# Office Action Summary

10/763,658

KAZAR ET AL.

Wilson Lee

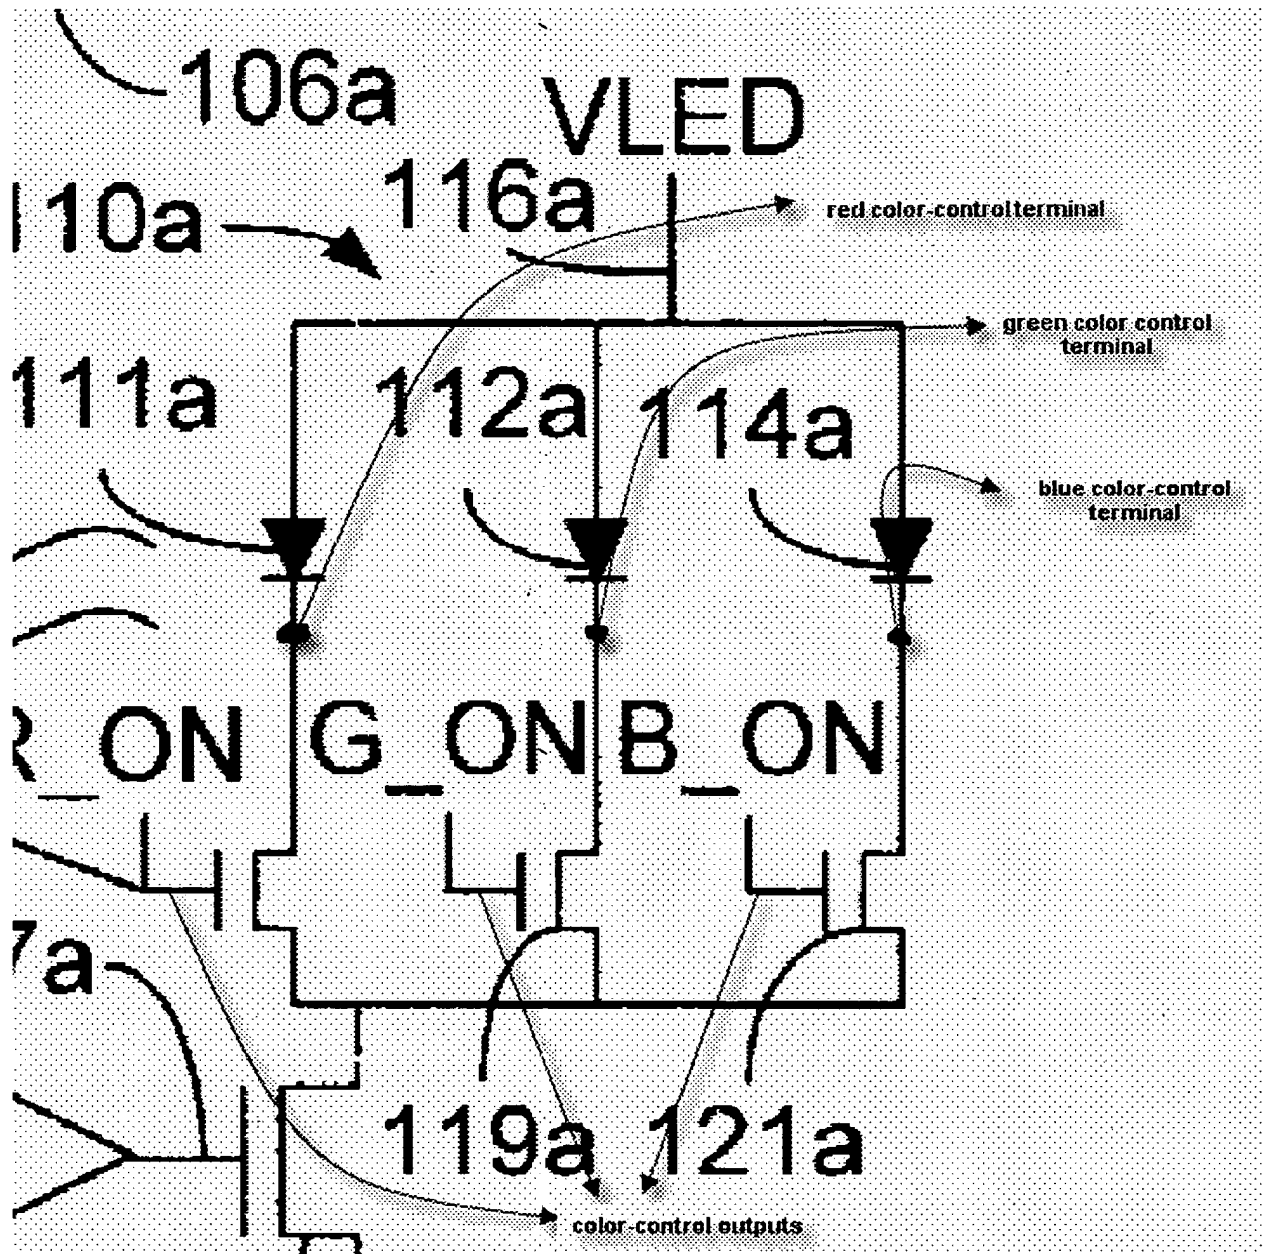
Claims 1, 2, 5, 6, 7, 13, 14, 16-18 are rejected under 35 U.S.C. 102(b) as being anticipated by Blalock et al. (6,344,641).

Regarding Claim 1, Blalock discloses a decorative lighting apparatus comprising

- control circuitry;
- a plurality of color-control outputs (labeled) from the control circuitry for coupling to color-control terminals (gates of 118a, 119a, 121a) of each one of a plurality of color-controllable lights (111a, 112a, 114a and 111b, 112b, 114b);

- the color-control outputs including a red color-control output (that coupled to 111a) for coupling to each red color-control terminal of the color-controllable lights;
- the color-control outputs including a green color-control output (that coupled to 112a) for coupling to each green color-control terminal of the color-controllable lights;
- the color-control outputs including a blue color-control output (that coupled to 114a) or coupling to each blue color-control terminal of the color-controllable lights;

- one or more set selection outputs (87a, 87b) from the control circuitry for selectively and individually enabling (LED1\_On and LED2\_On) at least a first set of one or more of the color-controllable lights and a second set (111b, 112b, 114b) of one or more of the color-controllable lights; and

- the control circuitry being operative to illuminate the color-controllable lights with a color scheme by repeatedly time-multiplexing color-control signals (See Col. 8, lines 49-55, Col. 10, lines 1-9 and Col. 11, lines 9-19) at the red, the green and the blue color-control outputs (See Col. 9, lines 47-50) to the first and second sets of color-controllable lights with use of the one or more set selection outputs.

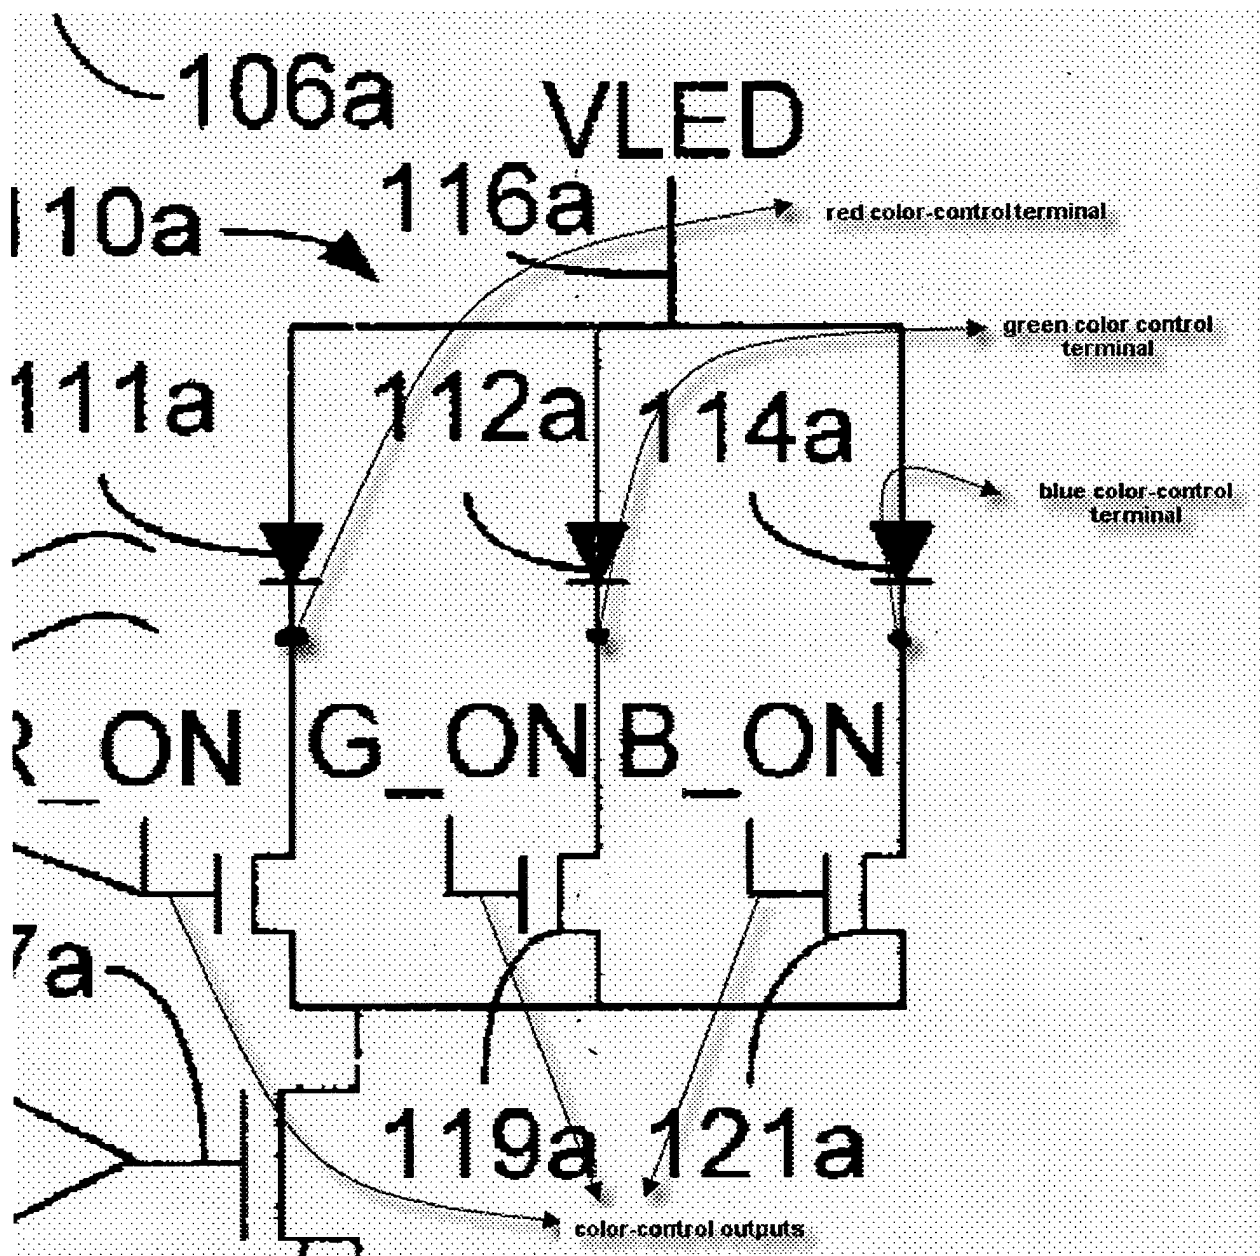
Regarding Claim 5, Blalock discloses that control circuitry being further operative to repeatedly time-multiplex the color control signals (See Col. 8, lines 49-55, Col. 10, lines 1-9 and Col. 11, lines 9-19) at the color-control outputs at a rate inherently sufficient such that the different sets of color-controllable lights appear to be simultaneously illuminated in order to render constant illumination.

Regarding Claim 6, Blalock discloses that scheme provides that at least first color (white) and a second color (non-white) (See Col. 3, line 62 to Col. 4, line 9) and wherein the first set (111a, 112a, 114a) is controlled to be illuminated with the first color (red) and the second set (111b, 112b, 114b) is controlled to be illuminated with the second color.

Regarding Claim 7, Blalock discloses that the control circuitry being further operative to illuminate a color of the color scheme in the color-controllable lights with current control at the color-control outputs (See Col. 11, lines 40-43).
